Delegated Report		Analysis sheet	Expiry Date:	01/10/2020
		N/A	Consultation Expiry Date:	05/09/2020
Officer			Application Number(s)	
David Peres Da Costa			2020/2936/P	
Application Address			Drawing Numbers	
23 Ravenshaw Street London NW6 1NP			Refer to draft decision notice	
PO 3/4	Area Team Signature	C&UD	Authorised Officer Signature	
Proposal(s)				
Erection of a three storey plus basement building comprising 7 Class C3 flats (4 x 3-bed units and 3 x 2-bed units) with balconies at rear following the demolition of the existing house.				
Recommendation(s):		Refuse planning permission		
Application Type:		Full planning permission

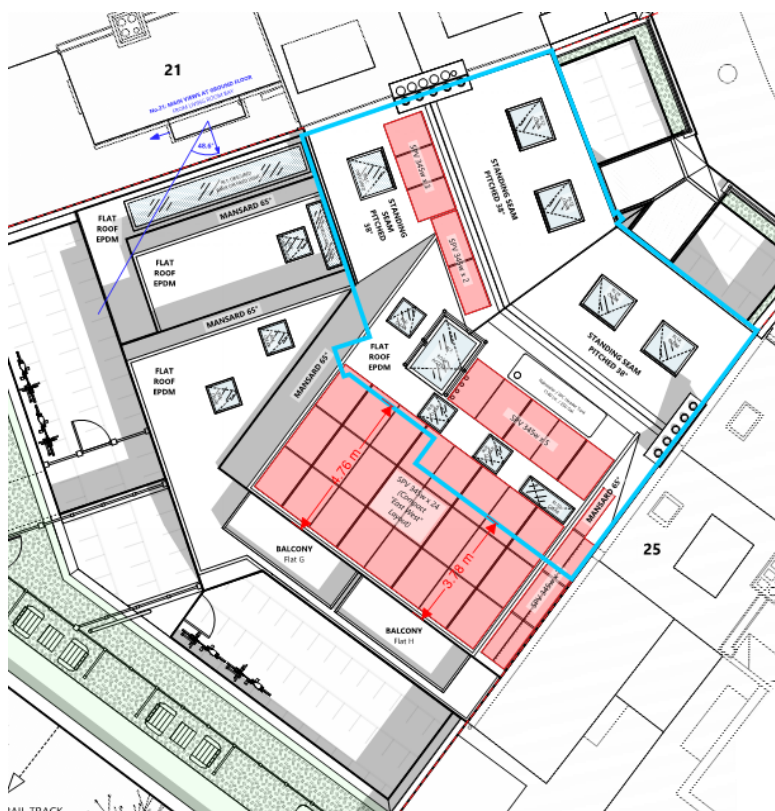
- 2.27. A comparison of the first floor of the appeal scheme and the current application demonstrates that the overall dimensions are very similar. The plan shown below is the appeal scheme with the outline of the current application laid over the top (as shown by the blue line)

2.28. A comparison of the second floor of the appeal scheme and the current application shows that the second floor of the current application has been significantly pulled back from the depth of the second floor sought at appeal. The plan shown below is the appeal scheme with the outline of the current application laid over the top (as shown by the blue line)

2.29. While the size of the second floor has been reduced, the design draws on oversized dormers in this street and neighbouring streets as a precedent. This results in the proposed southern dormers appearing disproportionately large.
